Ad Hoc Committee on Waterfront West
Councilor Jared Eigerman, Chairman
60 Pleasant Street
Newburyport, MA 01950

RE: Waterfront West Open Space

19 November 2018

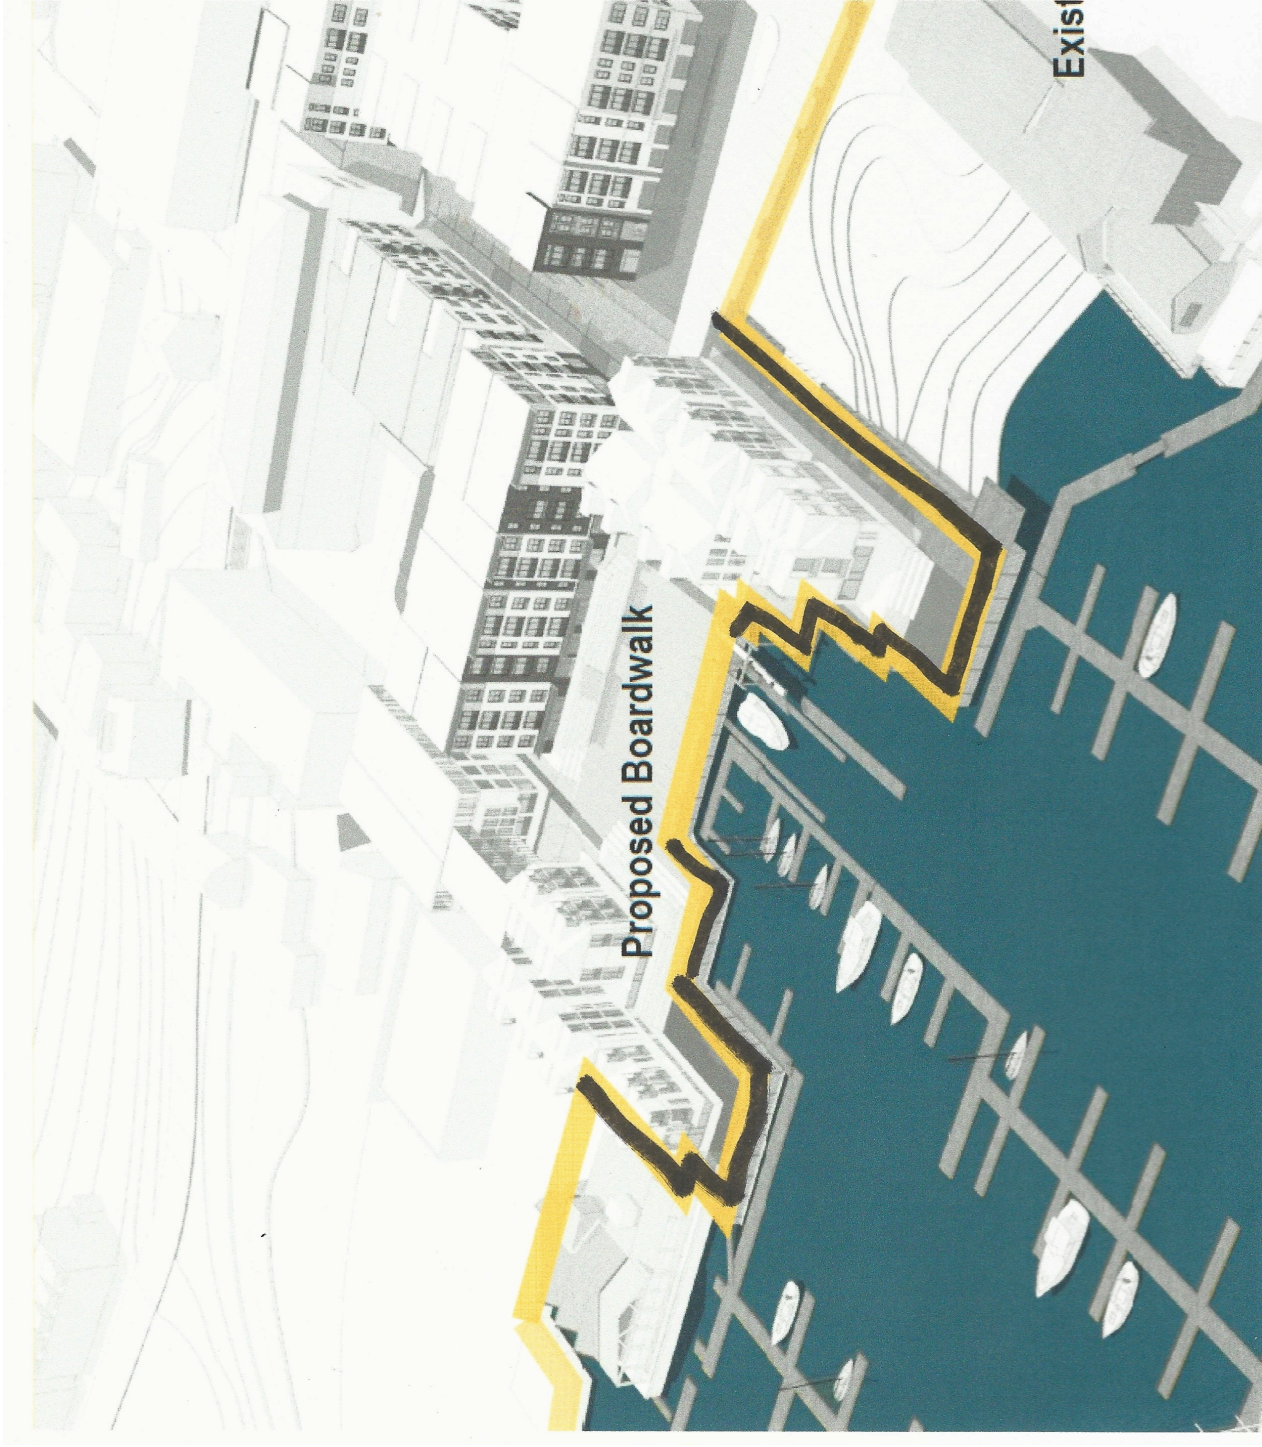
The current NED proposal uses definition 3), and claims ample open space. I urge the committee to consider adopting the definition of “pedestrian open space” as space where vehicles may transit, but there is no parking whatsoever allowed, even on a temporary basis. (Newburyport parking clerks should be allowed to enforce.)

True pedestrian open space (Vehicles may transit, no parking, even temporarily)

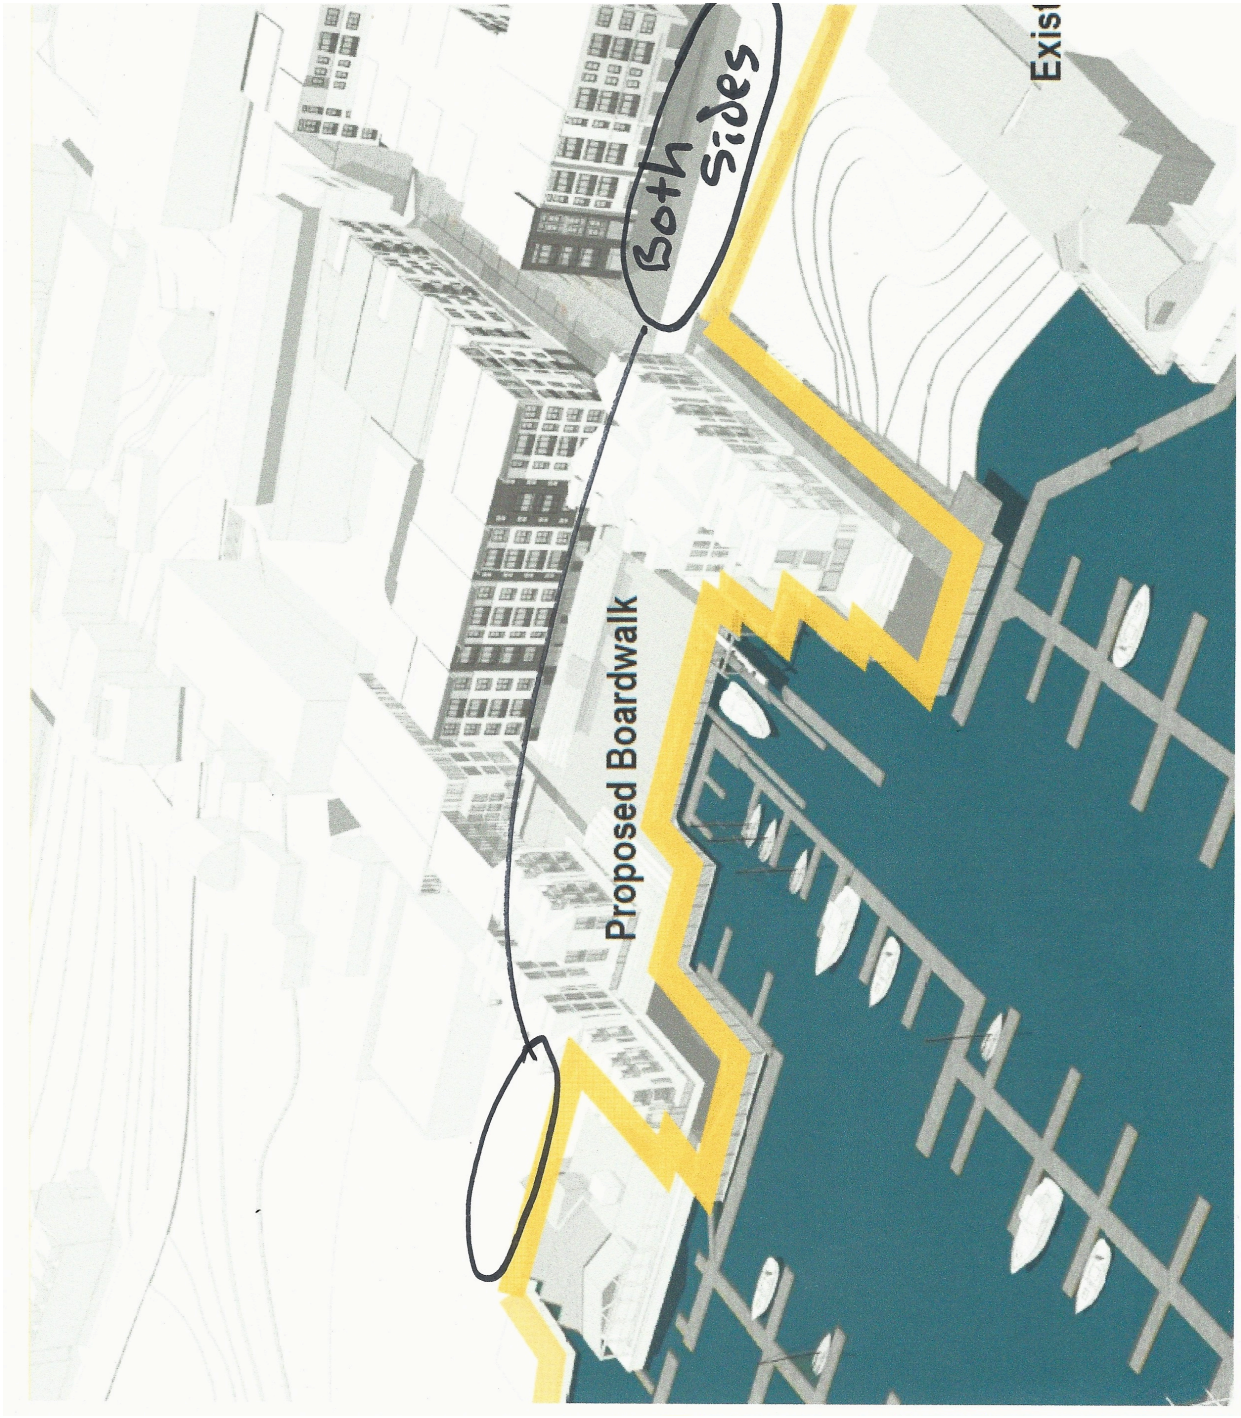
Still marina parking, make some spaces loading/ unloading only.
